UNITED STATES PATENT AND TRADEMARK OFFICE

APPLICATION NO.	FILING DATE	FIRST NAMED INVENTOR	ATTORNEY DOCKET NO.	CONFIRMATION NO.
10/037,304	12/31/2001	Huanong Zhang	X02.12-0001	4512

Office Action Summary

DETAILED ACTION

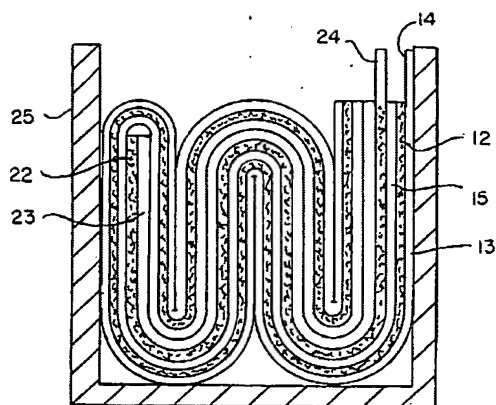
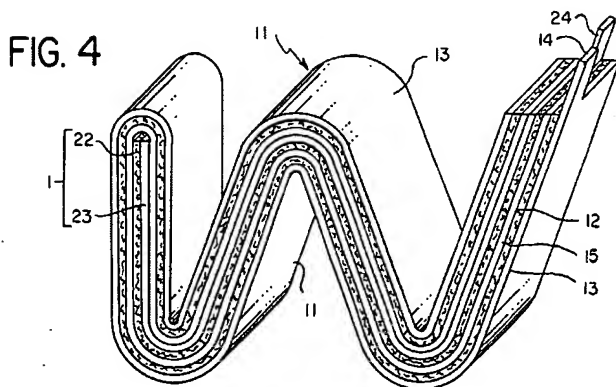
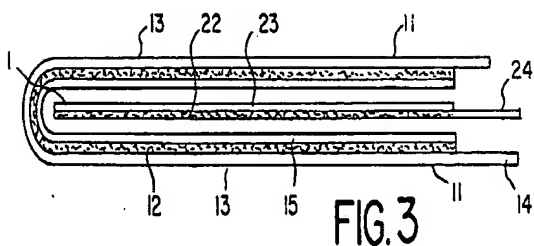
Figures 3, 4 and 5 below show the electrode assembly wherein the method for assembling the same including folding the entire anode over the entire cathode to form an alternately laminate structure in which the cathode 1 is sandwiched between the folds of the anode 11 (COL 3, lines 1-6). It is further disclosed that the invention works equally well when the separator is placed over the cathode (COL 2, lines 45-48).

Figures 3, 4 and 5 above illustrate one plate being folded into a continuous S-shape along with the separator integrally, and the other plate being sandwiched (*inserted*) in the laminated area (COL 3, lines 1-6).

Figures 3, 4 and 5 above also depict the plate having a continuous S-shape folded plate and the notches (*the V-shaped indentation or fold*) provided at the cross-positions of the two plates (COL 3, lines 7-19).

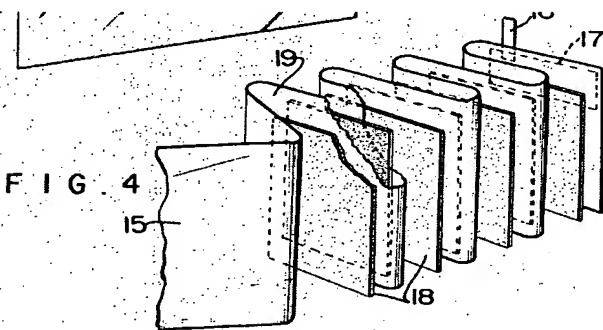
Figure 4 below illustrates the assembled battery group wherein the anode plate is folded; the positive and negative plate alternately arranged, the cathode plate being inserted into a laminated area of the anode plate and the separator.
